ADDENDUM No. 1

DATE: November 22, 2024

PROJECT: Village of Algonquin
Braewood Pump Station Rehabilitation

TAI PROJECT NUMBER: ALG-037

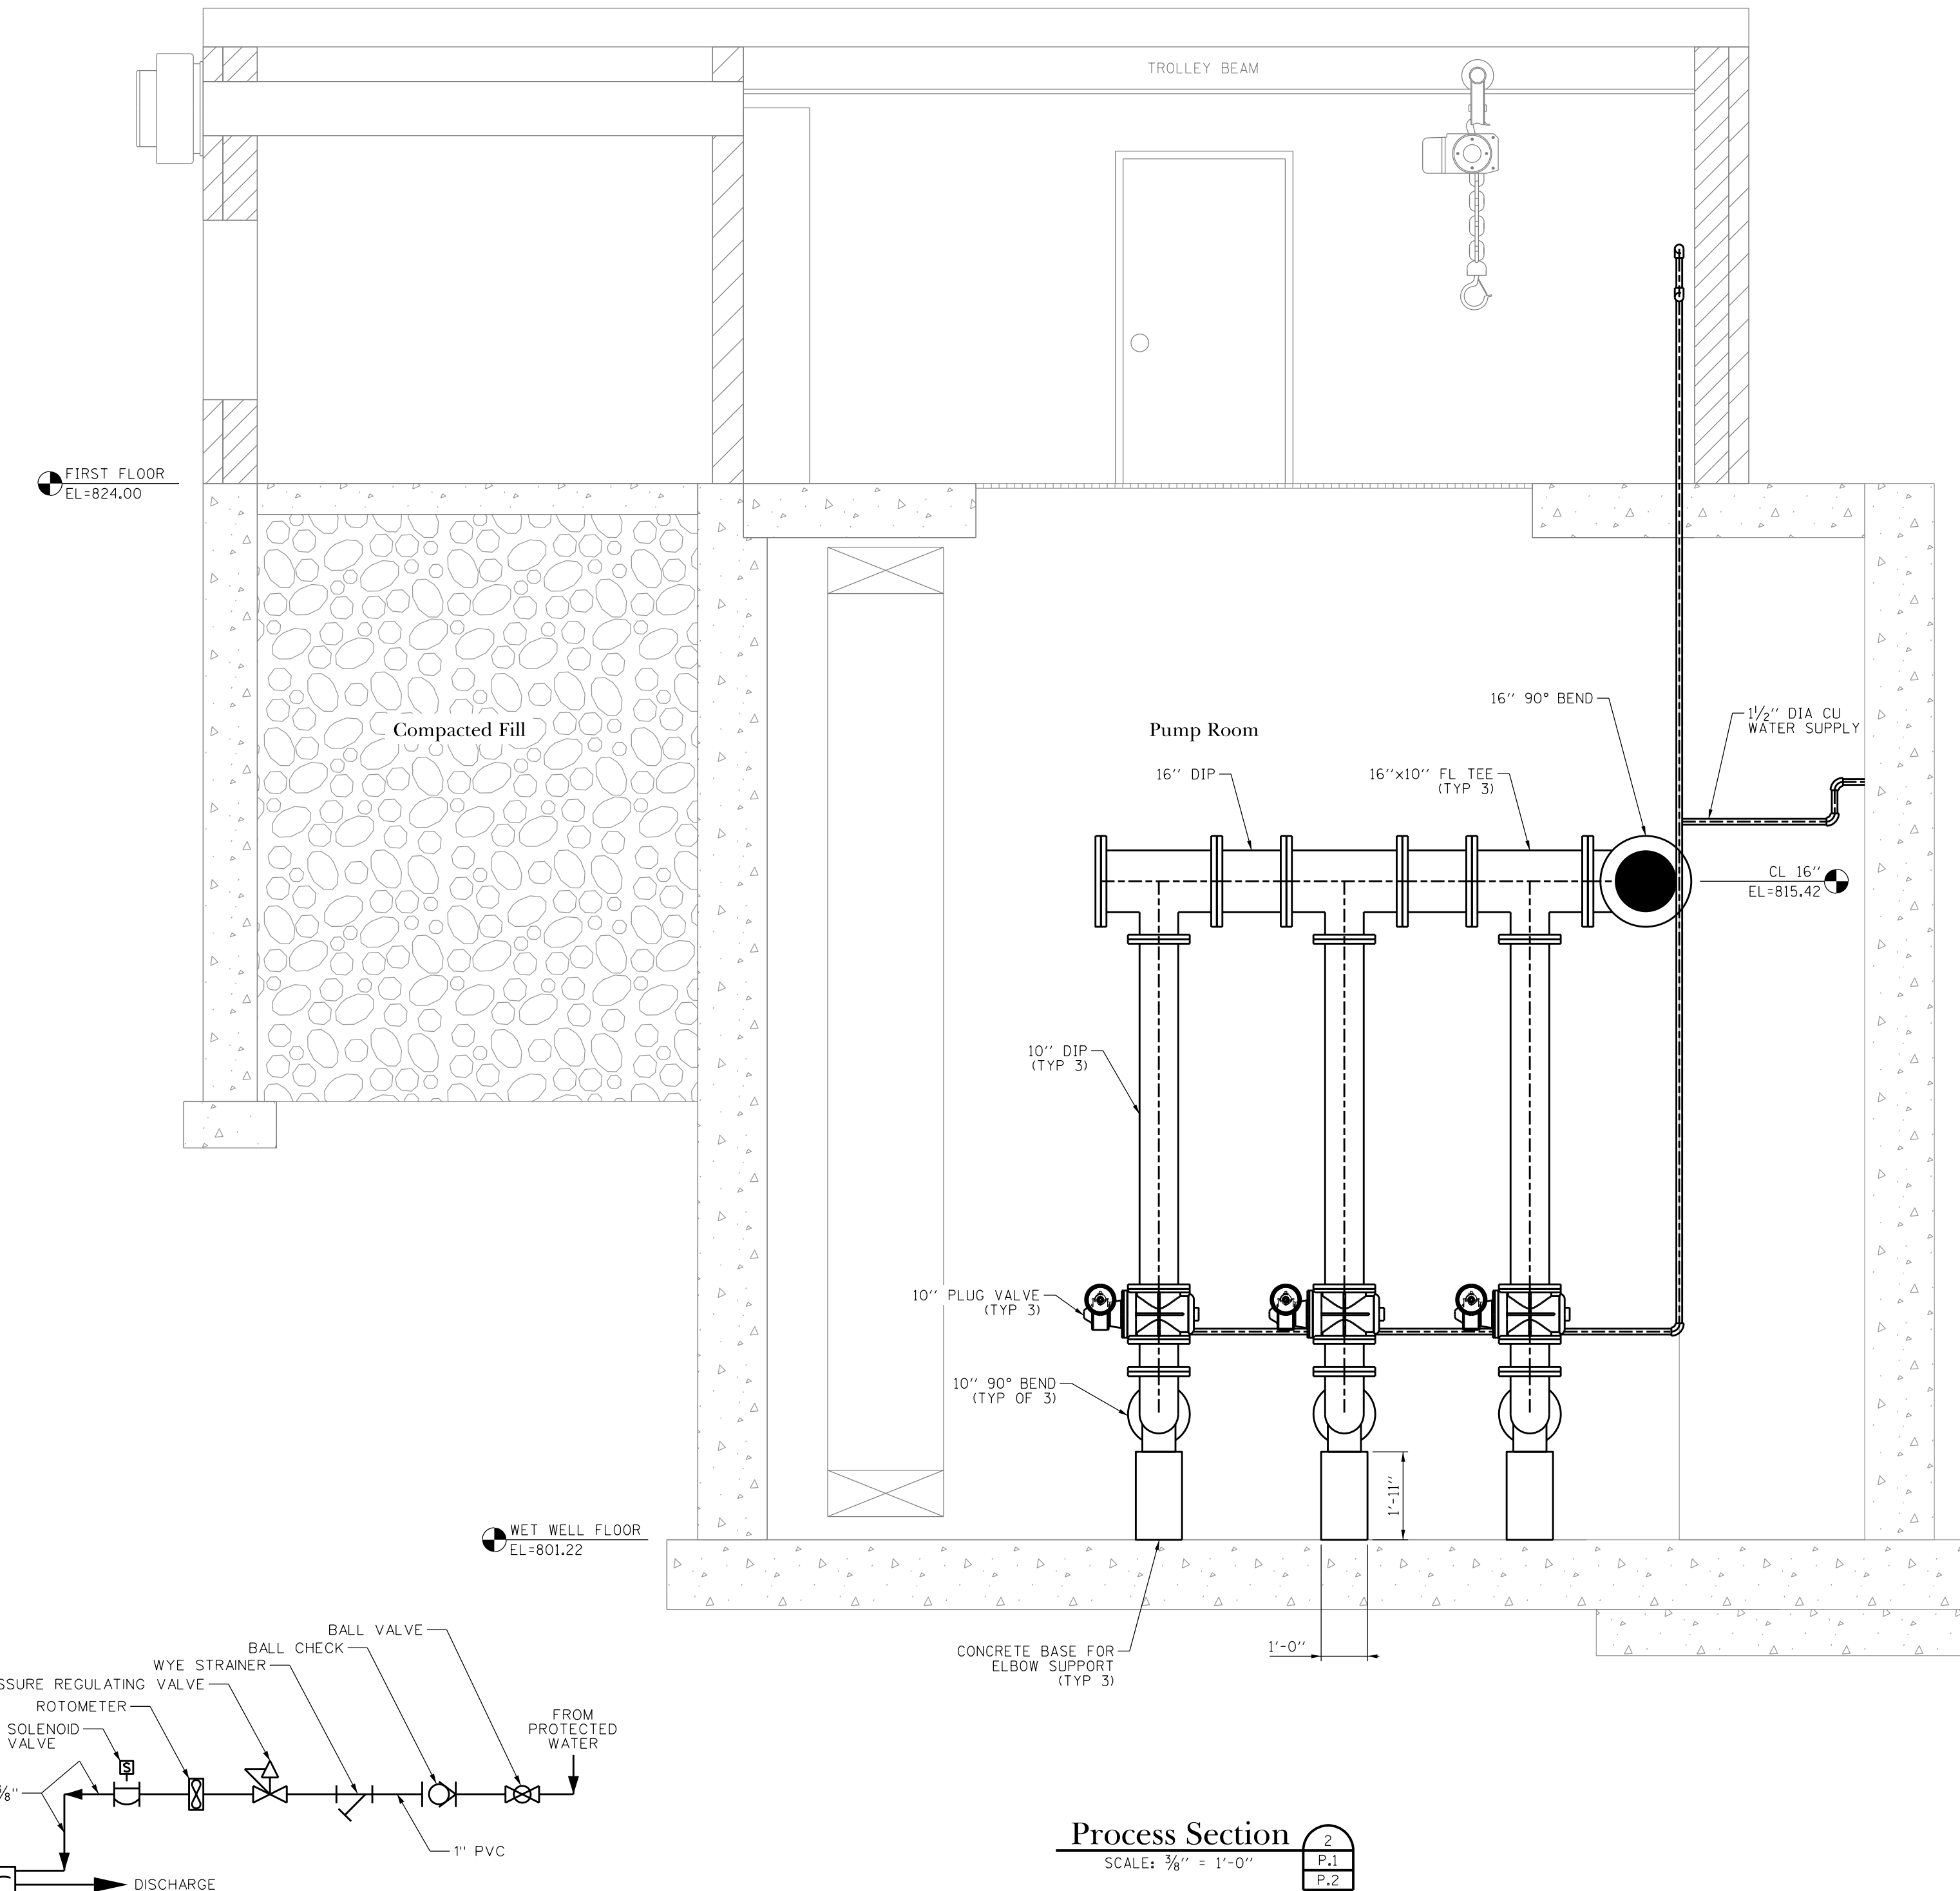
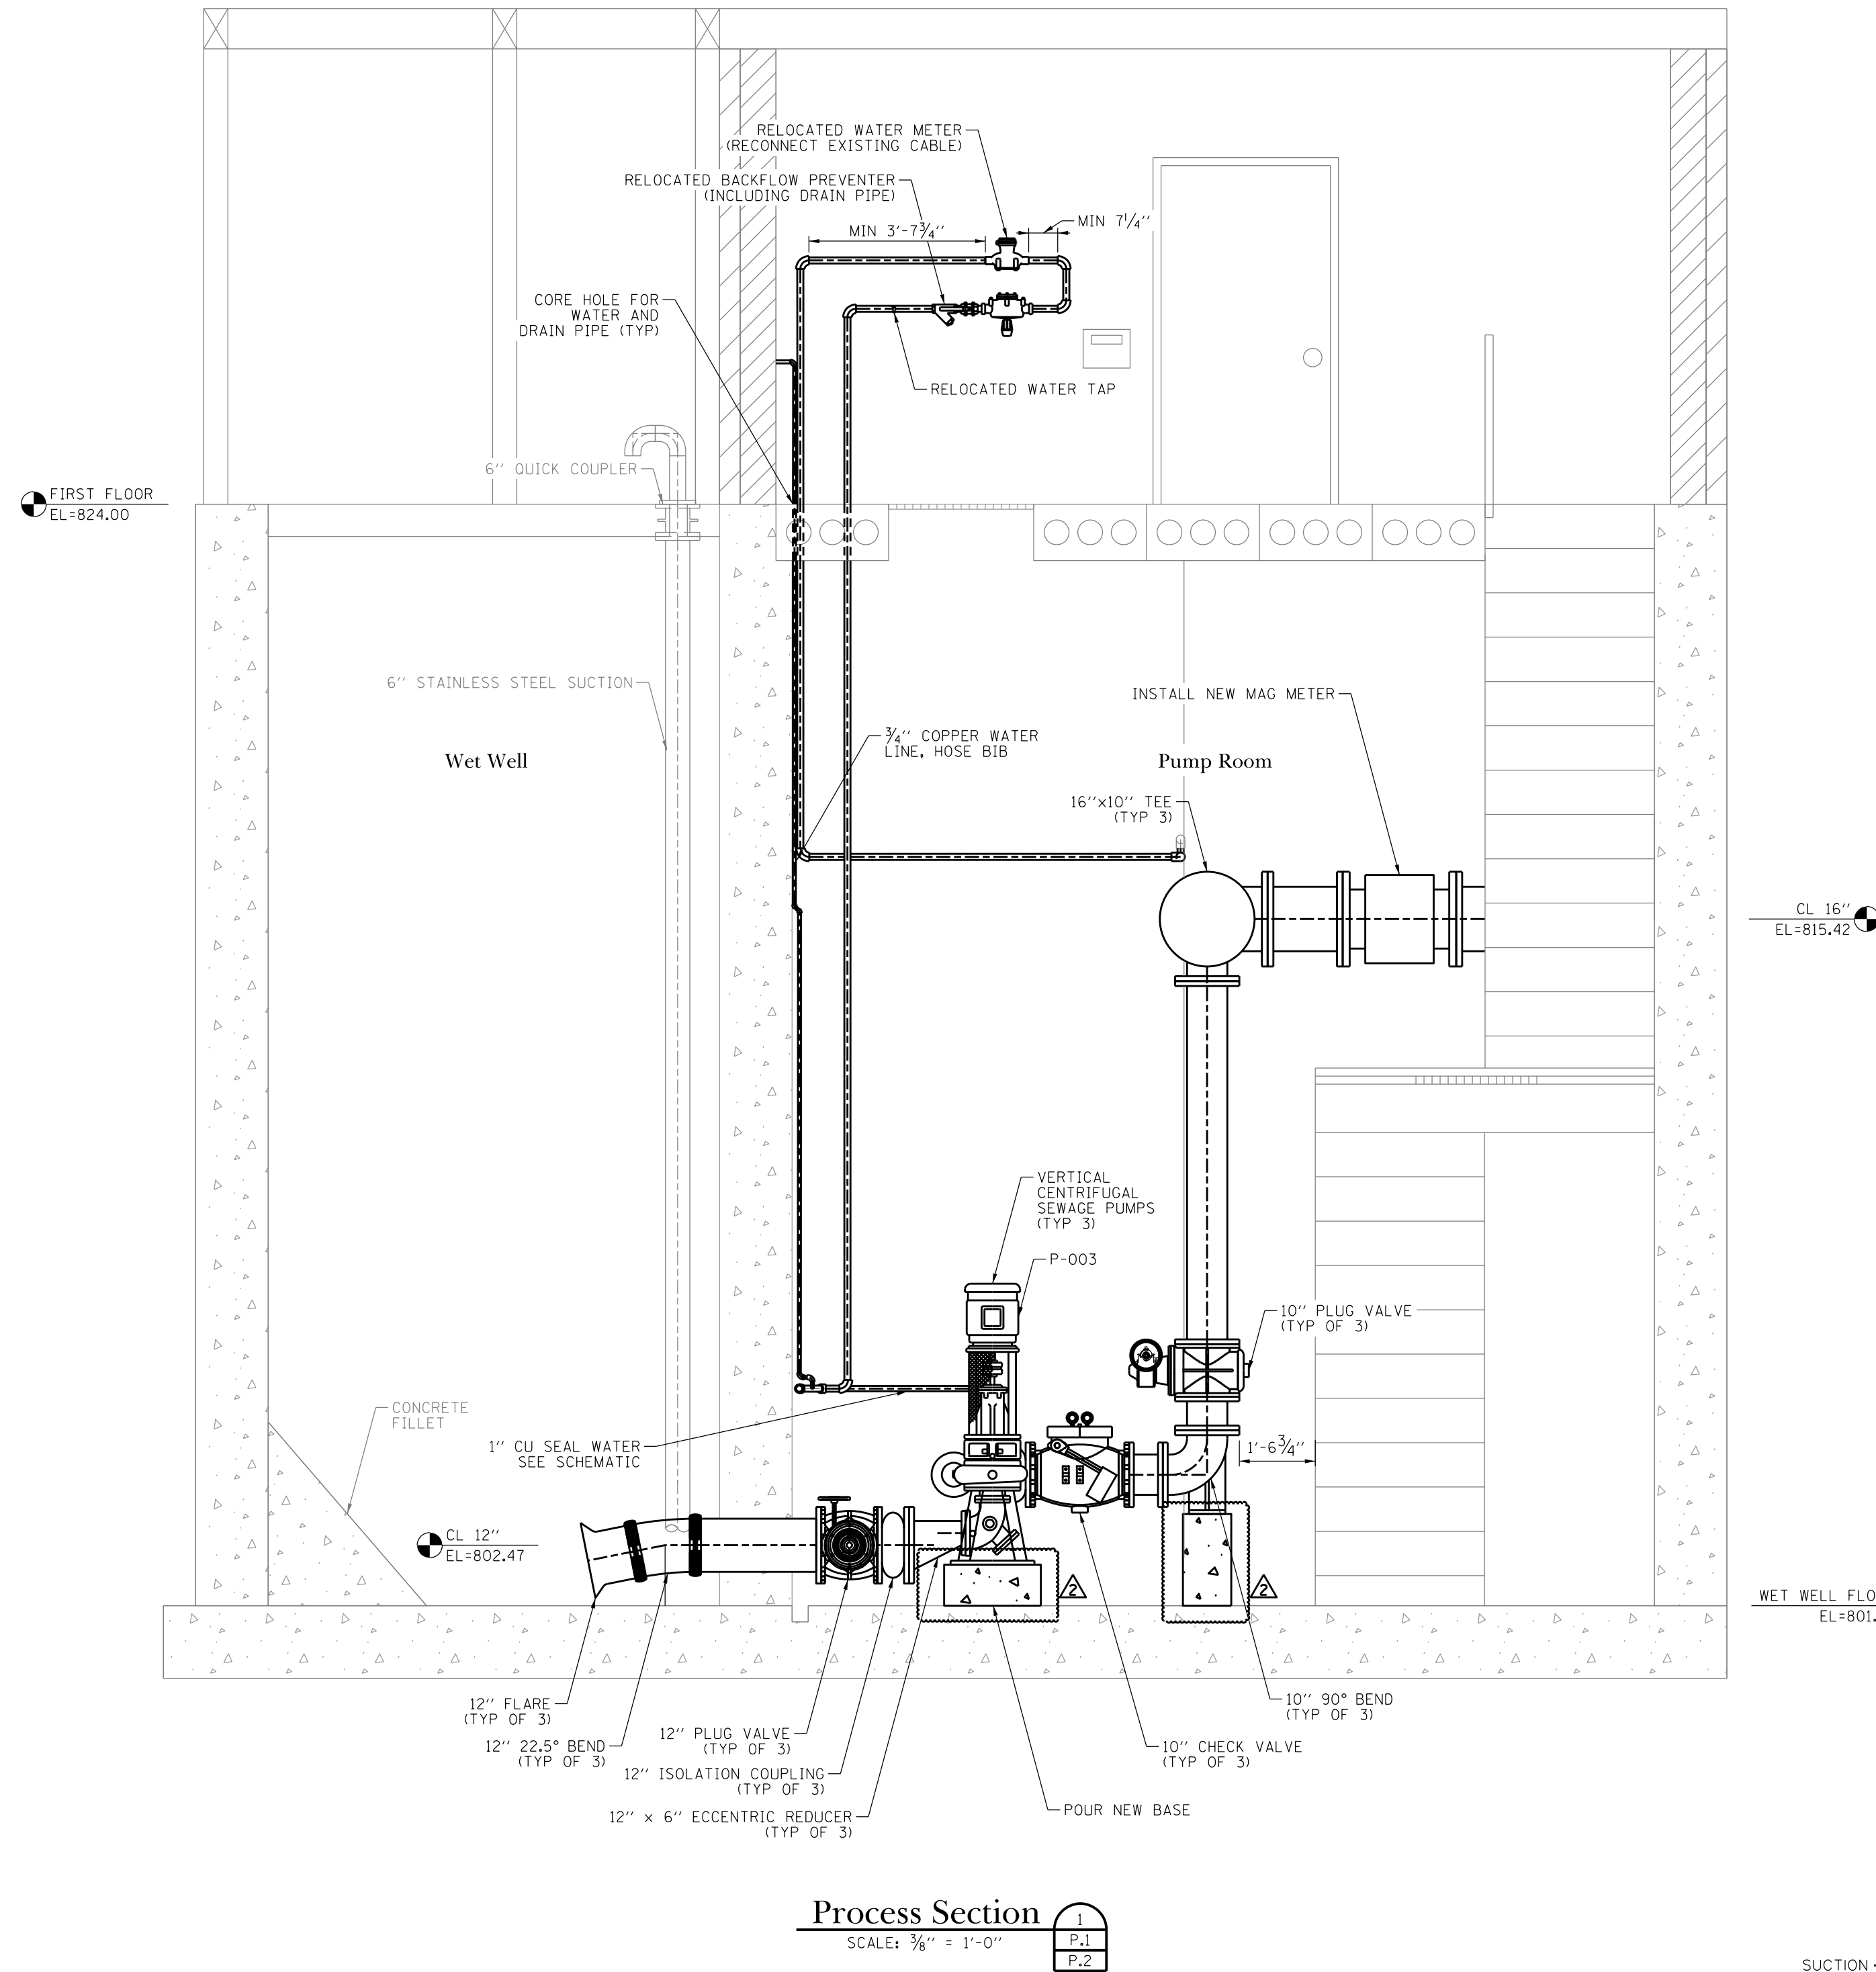
10. Sheet P.2 – Process Sections

- A. Equipment concrete pads shown under proposed pump and base elbows.
- B. Key note #8 removed.

Process Section
 SCALE: 1/2" = 1'-0"
 3
 P.1
 P.3

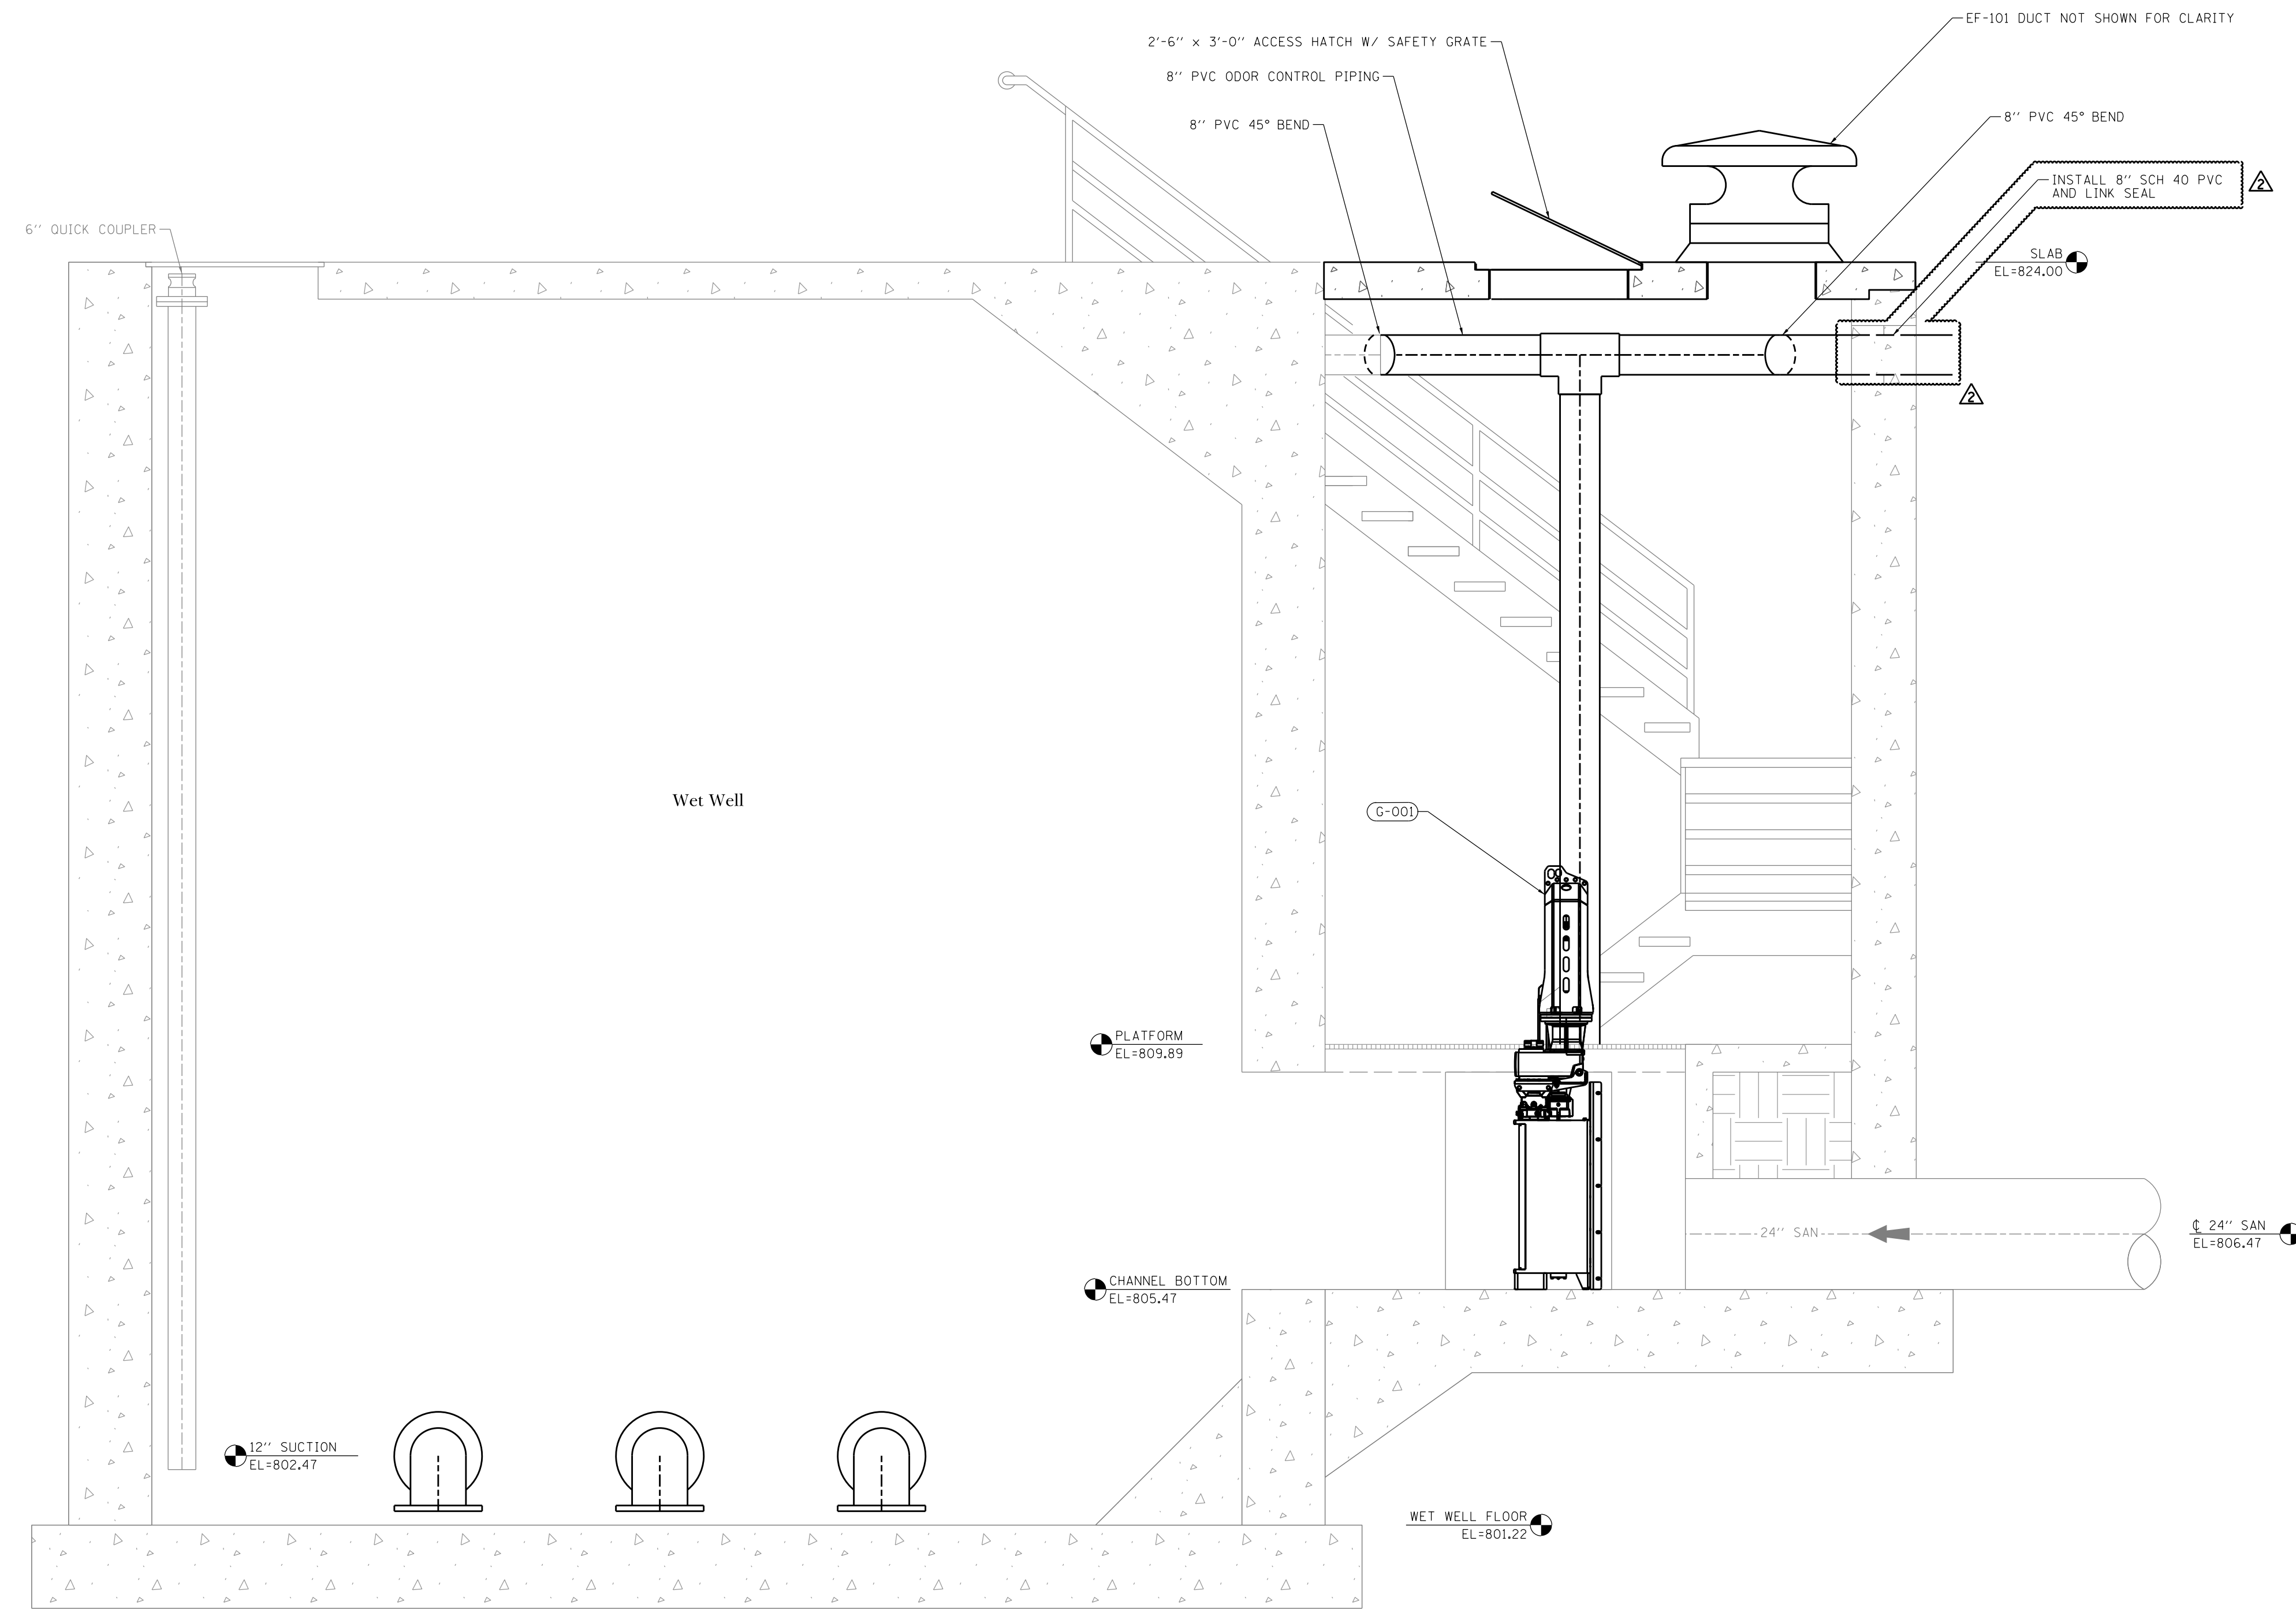
11. Sheet P.3 – Process Section

- A. Proposed odor control piping installation limits expanded.
